Report on Consultation - Route Selection Dunoon to Loch Long 132 kV OHL Rebuild

REF: LT000193-WSP-ENV-RPT-001

Scottish & Southern
Electricity Networks

Plate 3.1: Preferred Route

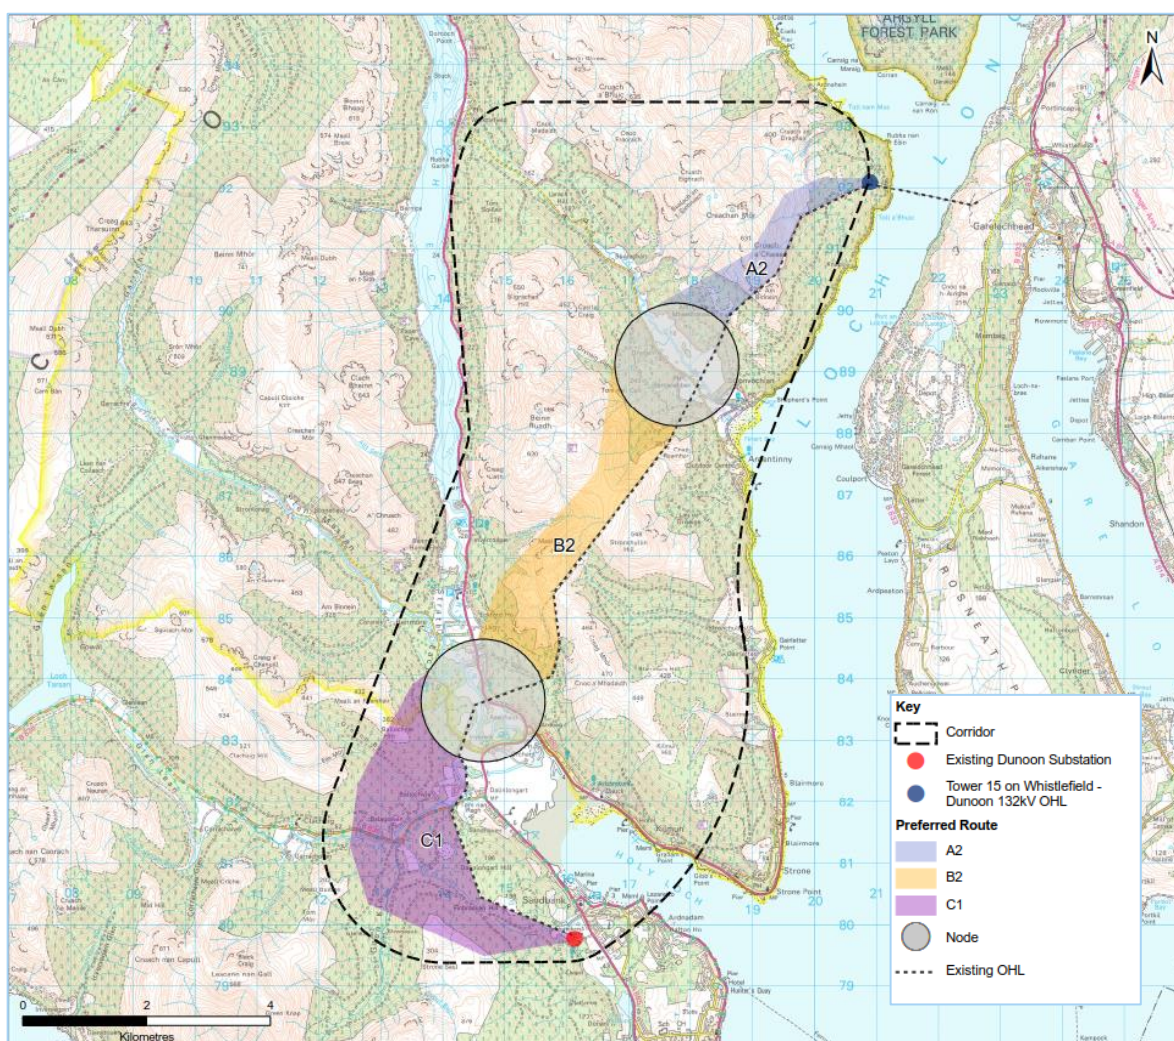
NatureScot	<p>Consider the Consultation Document adequately explains the project and approach to selection of the Preferred Route. On balance consider the Preferred Route is the most appropriate for further consideration at the alignment selection stage.</p> <p>Provide further points for consideration on designated sites, protected species, freshwater pearl mussel (FWPM), ornithology, habitats and invasive non-native species.</p> <p><u>Designated sites</u></p> <p>Agree with the exclusion of Route Option AB1 due to the potential effects on the Loch Eck Site of Special Scientific Interest (SSSI).</p> <p>Natural heritage sensitivities in the marine environment will also need to be considered in future assessments.</p> <p>Craighoyle Woodland SSSI, which lies partially within the Preferred Route, could be affected by the proposal.</p> <p>Construction could have the potential to lead to an increase in sedimentation and pollution runoff to the Upper Loch Fyne and Loch Goil Nature Conservation Marine Protected Area (NC MPA).</p>	<p>The potential for impacts upon natural heritage assets and upon the Upper Loch Fyne and Loch Goil Nature Conservation Marine Protected Area were considered within the Consultation Document and will continue to be considered through future design stages and assessment work. Effects would be minimised through considerate construction design and the implementation mitigation to protect the marine environment through a suitable Construction Environmental Management Plan (CEMP).</p> <p>It is acknowledged that the Preferred Route could potentially impact Craighoyle Woodland SSSI. Further design work will seek to identify an alignment which avoids or minimises potential impacts to this designated site. If appropriate, mitigation will be considered and further consultation on this matter will be undertaken with NatureScot.</p> <p>SHE Transmission acknowledge the requirement for a survey license for undertaking FWPM surveys. It is</p>

Stakeholder	Summary of Feedback	Response by SHE Transmission
		<p><i>route which utilises Route Options A2 and B2 would be preferred as they would not introduce an OHL into a currently unaffected area of landscape and they avoid the more densely settled areas east of the existing OHL. However, this is on the understanding that an alignment can be found that avoids an unacceptable effect on Puck's Glen'. The alignment stage of the project will be informed by further landscape surveys and appraisal work.</i></p> <p>The LLTNP Ecologists comments on the Preferred Route are acknowledged and the Craighoyle Woodland will be avoided at the alignment stage. The effect on the SSSI will be considered during the development, appraisal and selection of a preferred alignment. Further consultation will be undertaken with NatureScot and other relevant stakeholders to help inform the alignment stage including identifying a route within the southern node at the River Eachaig.</p> <p>As noted above further landscape and ecology survey work is proposed to be undertaken to inform the alignment stage, with further work also undertake for the EIA stage of the project. SHE Transmission consider that the Preferred Route is the most appropriate route, as outlined in the assessment work undertaken to data and documented in the Consultation Document.</p> <p>SHE Transmission appreciate the importance of working in partnership with LLTNP and propose to undertake further detailed discussions on the points raised by LTTNP during this consultation exercise and to inform the project going forward.</p>

The consultation process has confirmed that a combination of Route Options A2, B2 and C1 should be taken forward as the Proposed Route, within which further study will seek to identify alignment options. It is recognised that the Preferred Route runs through a sensitive environment with challenging terrain. However, the Preferred Route has been selected on the basis that it is considered to provide an optimum balance of environmental, technical and economic factors, and will become the Proposed Route taken forward to the alignment stage of this project.
